Addendum 2

RFQMA24 – 5030

Glenforest Secondary School City of Mississauga

Pool Demolition

A201

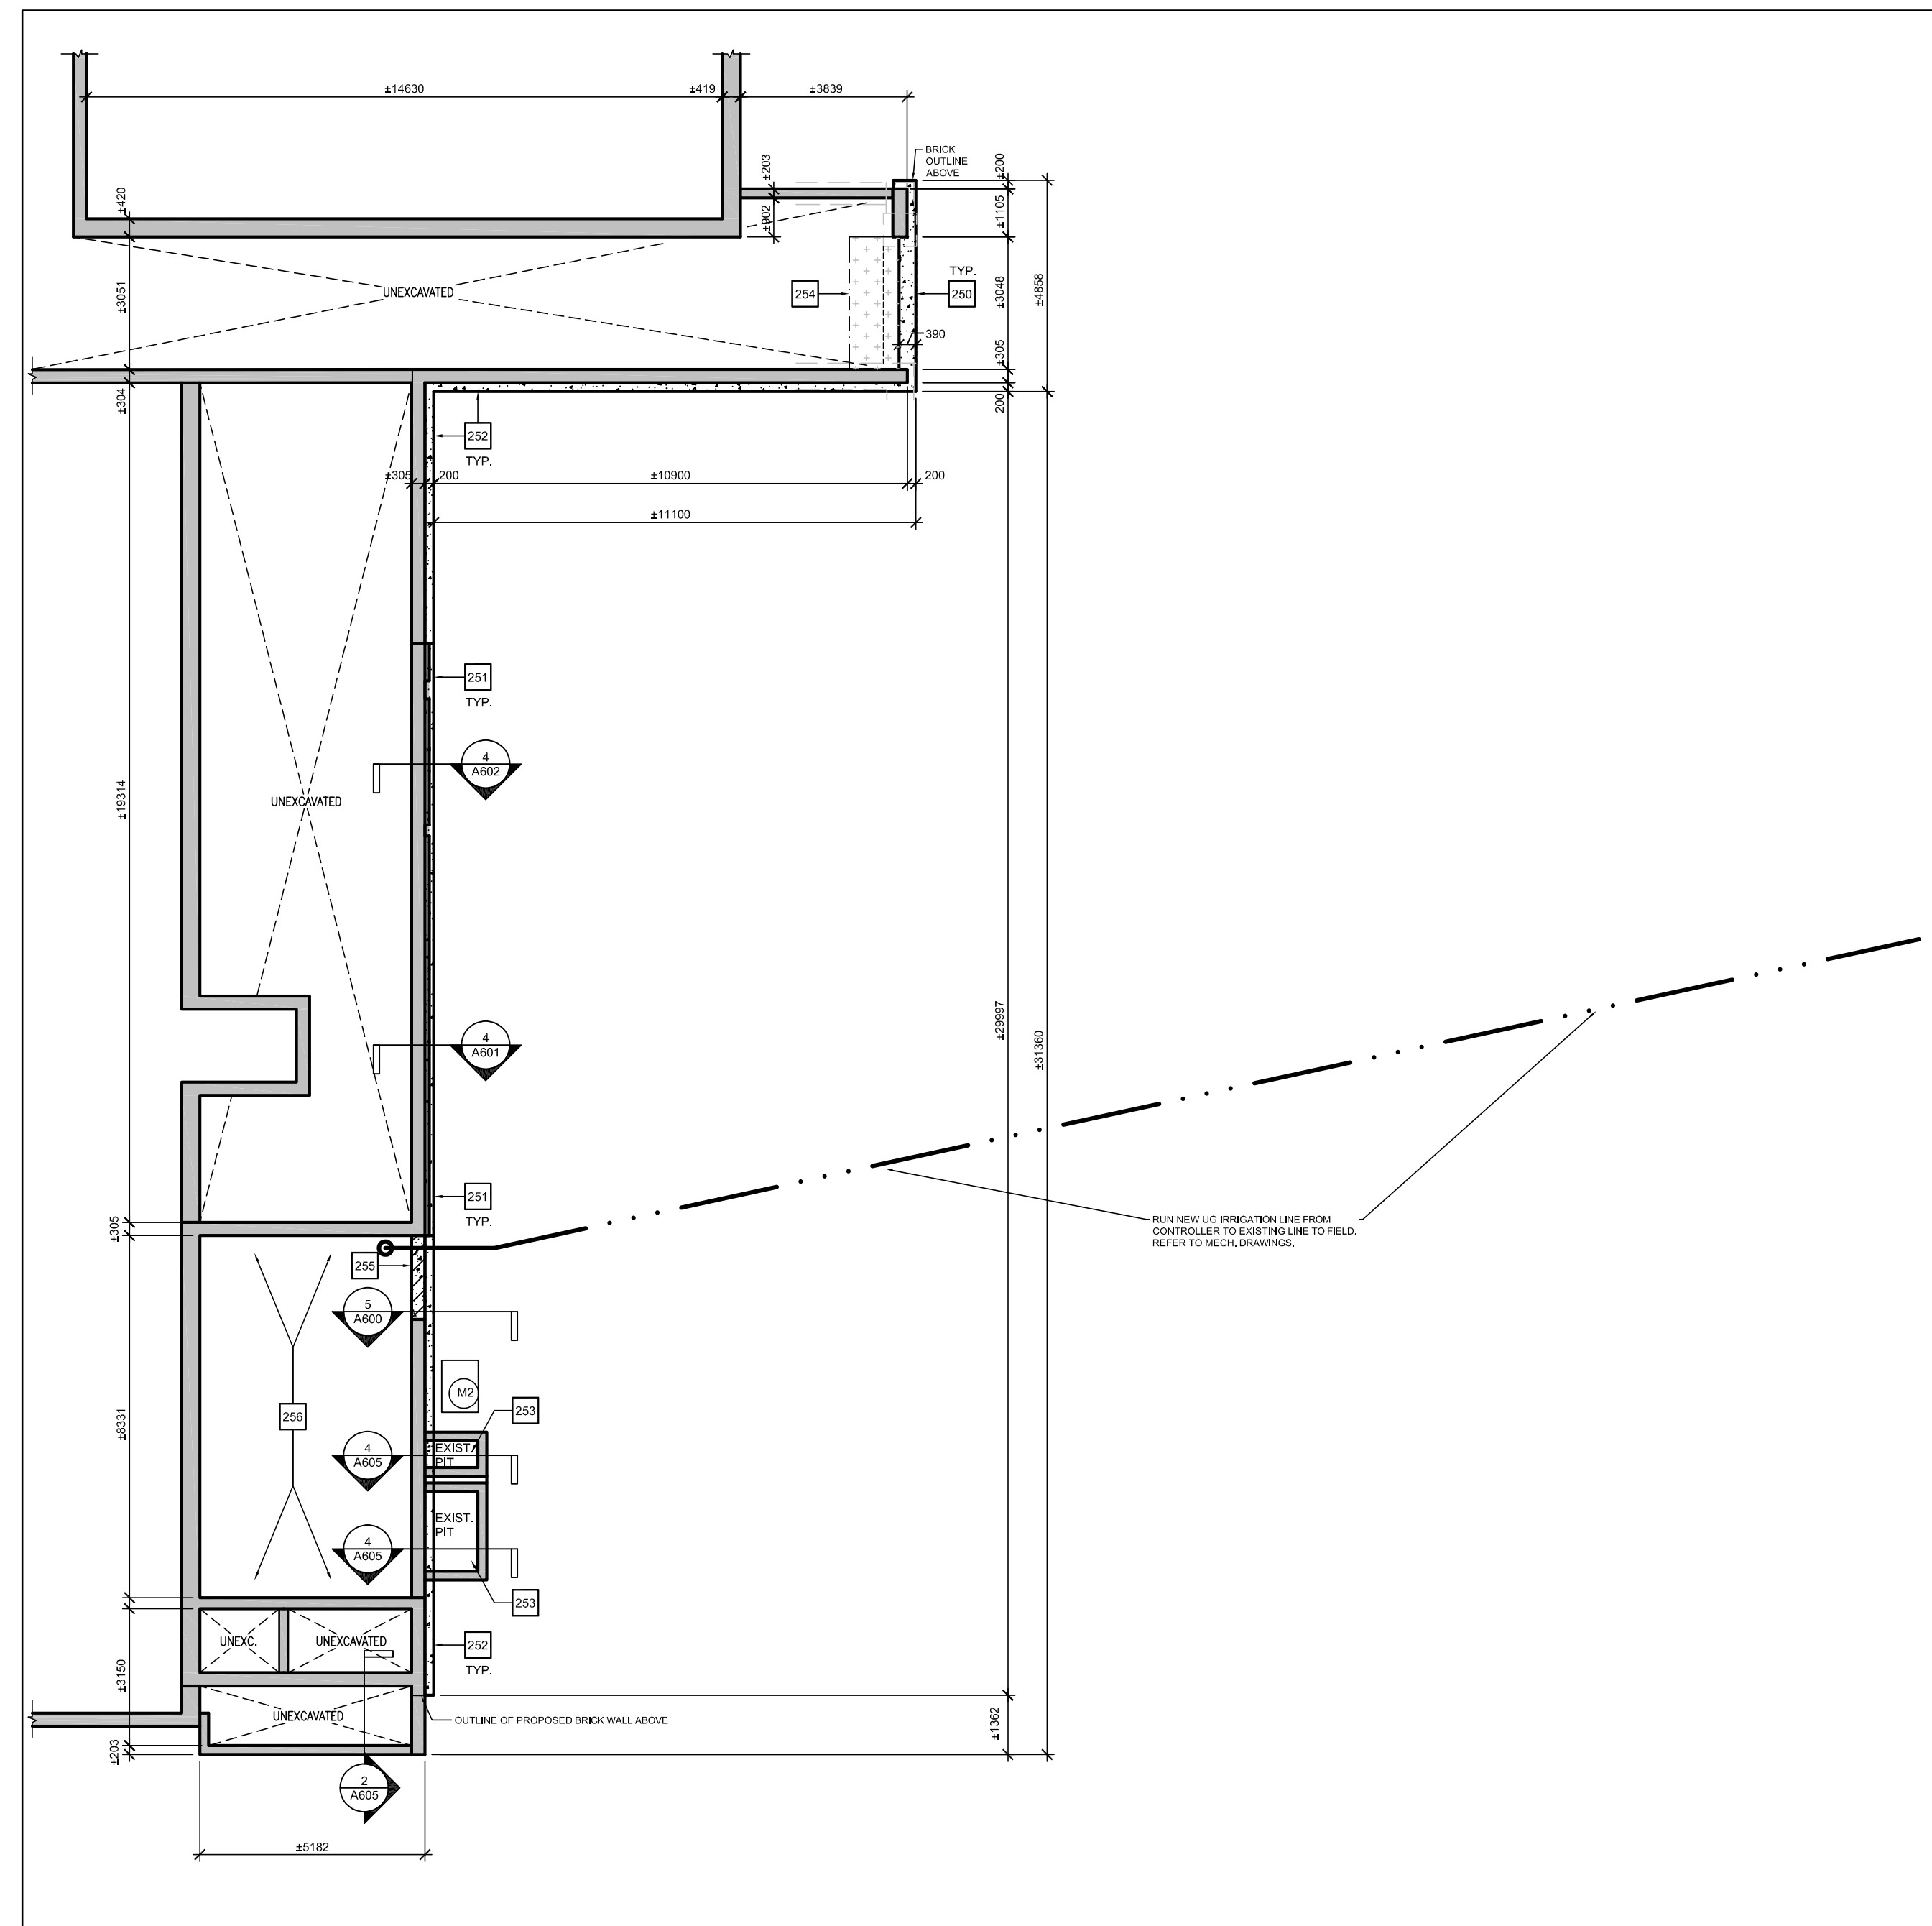
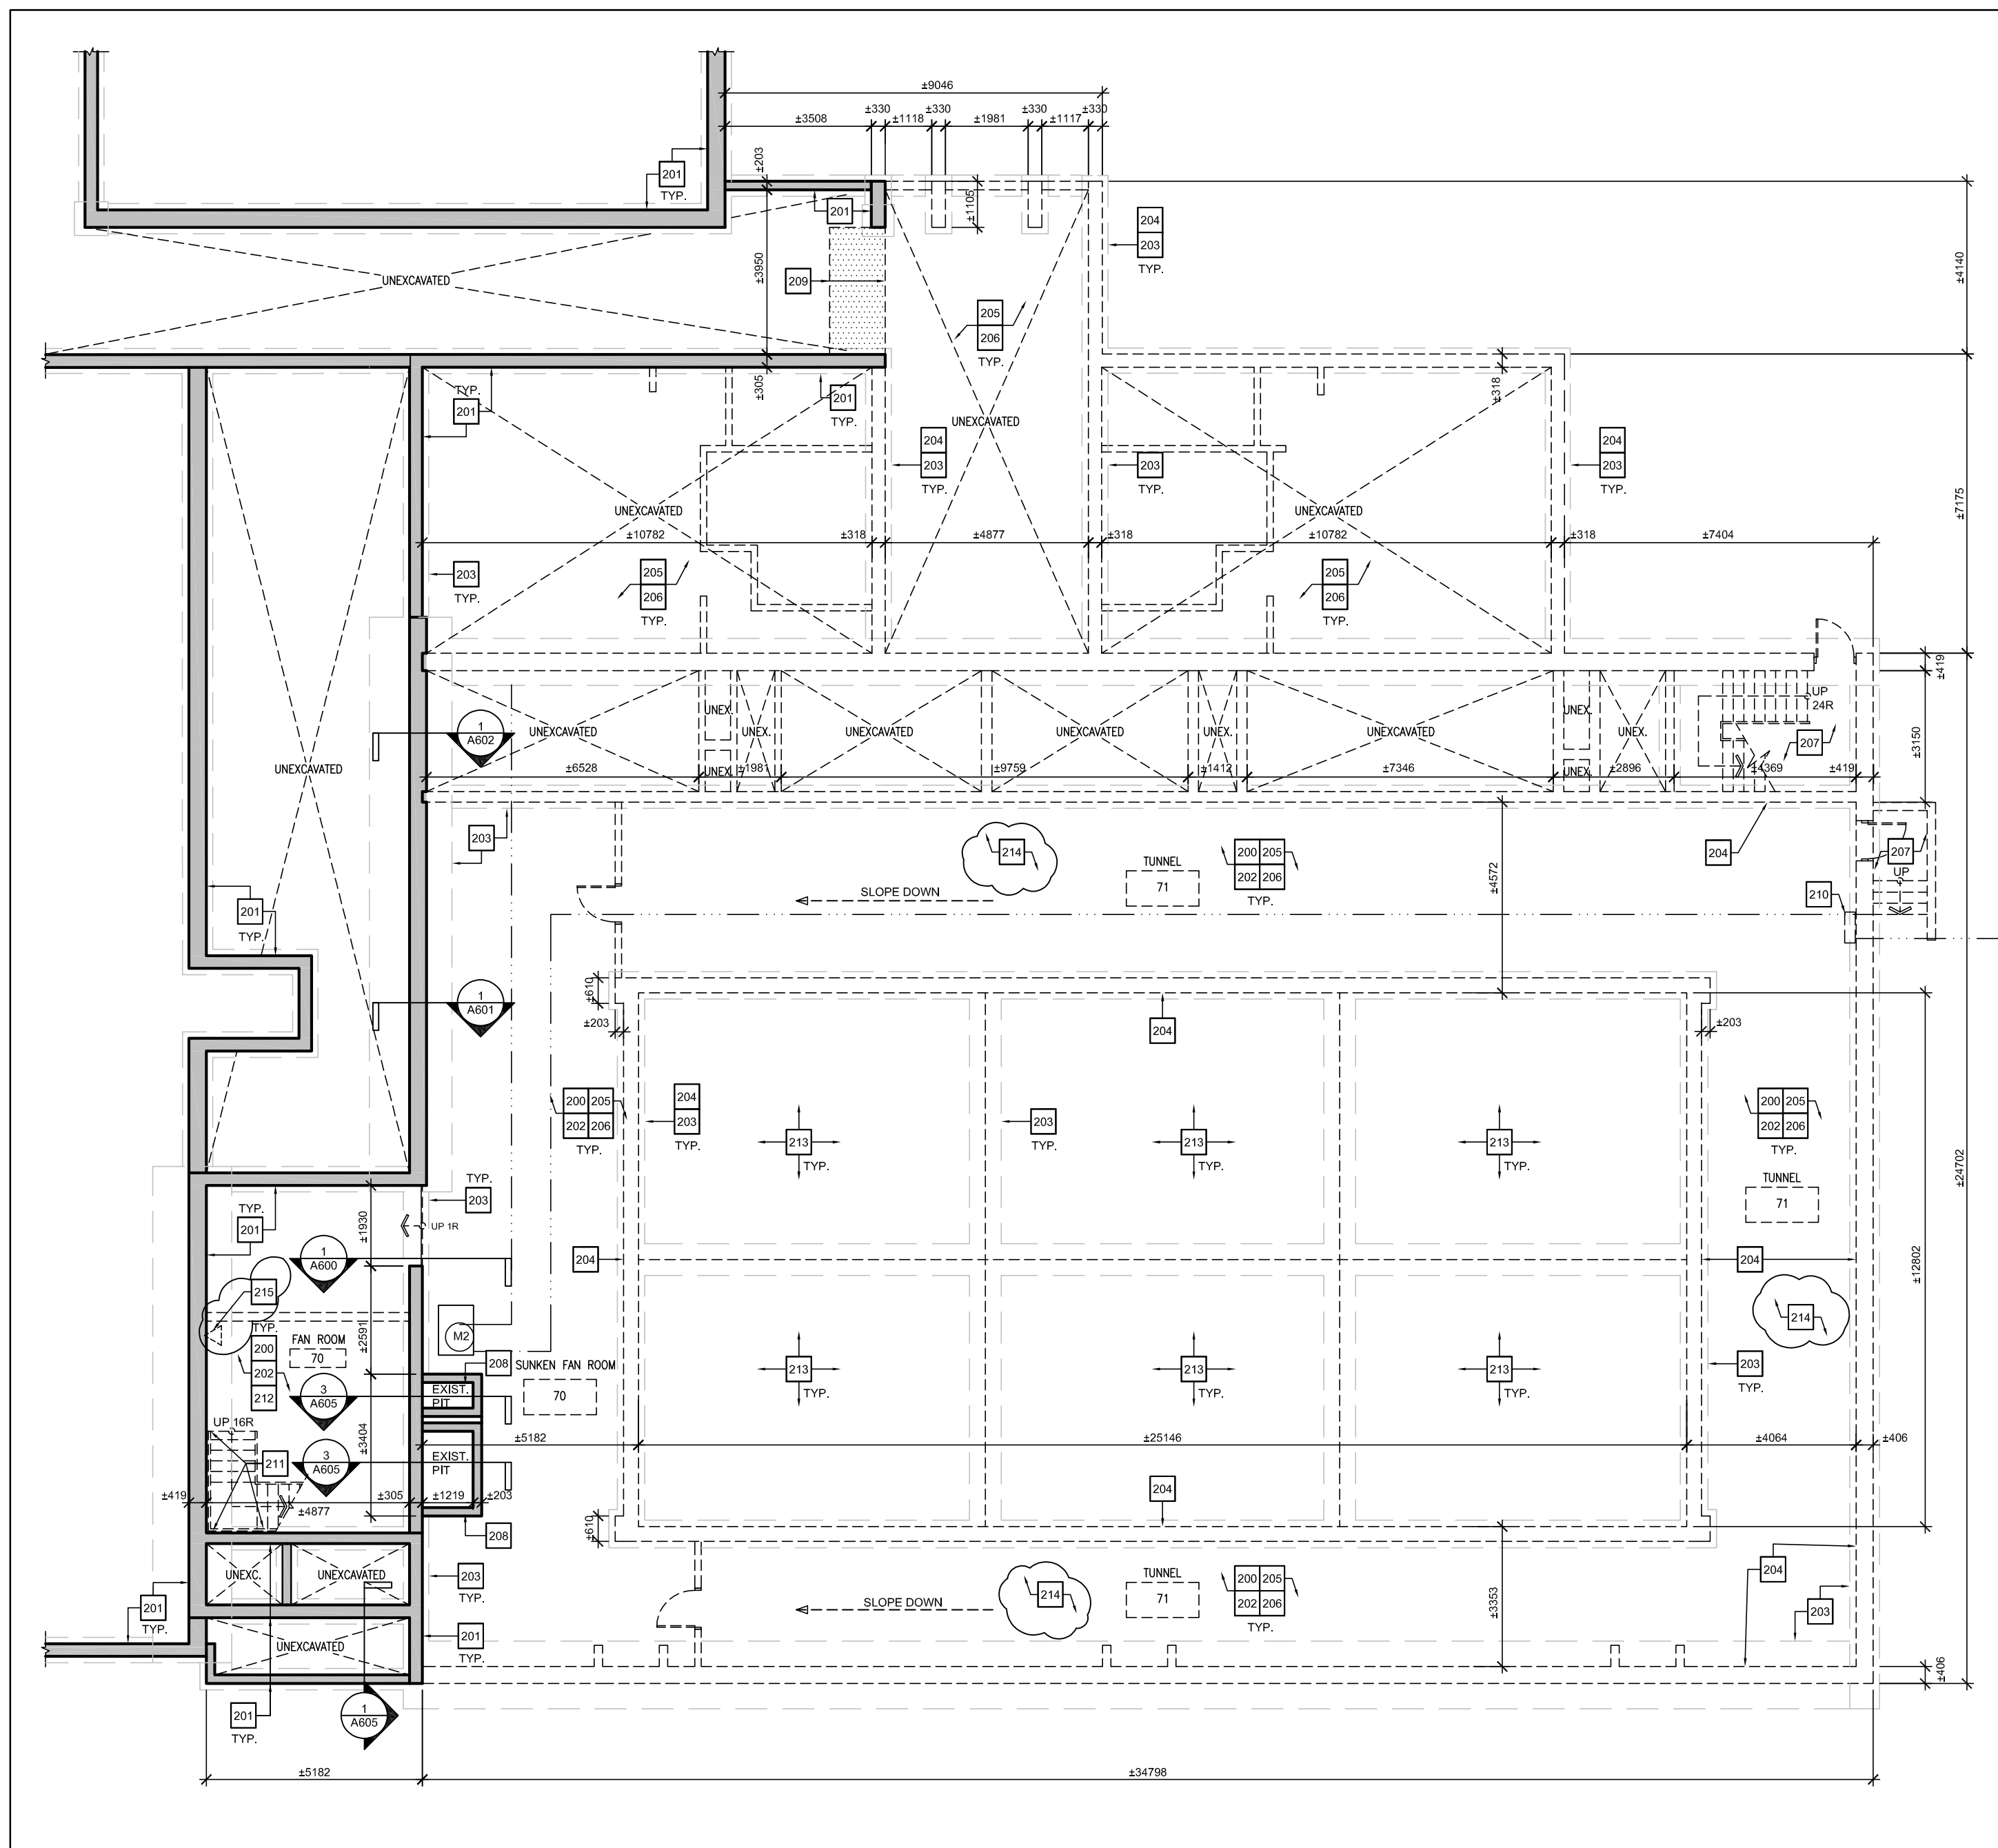
- 2.2.1. Refer to Mechanical Addendum no. M&E#1
- 2.3. Refer to note 4 on E5. GC to provide routing for conduit and wiring for relocated GFI Outlet. Location of outlet to be relocated to gym storage room. Exact location to be determined on site. See note 215 on A201, and note 284 on A202. Trace wire to panel, and refeed from panel.

- 2.5. Clarification: Additional notes 214 and 237 added to demolition floor plans A201 and A202, regarding thickness of floor slabs.
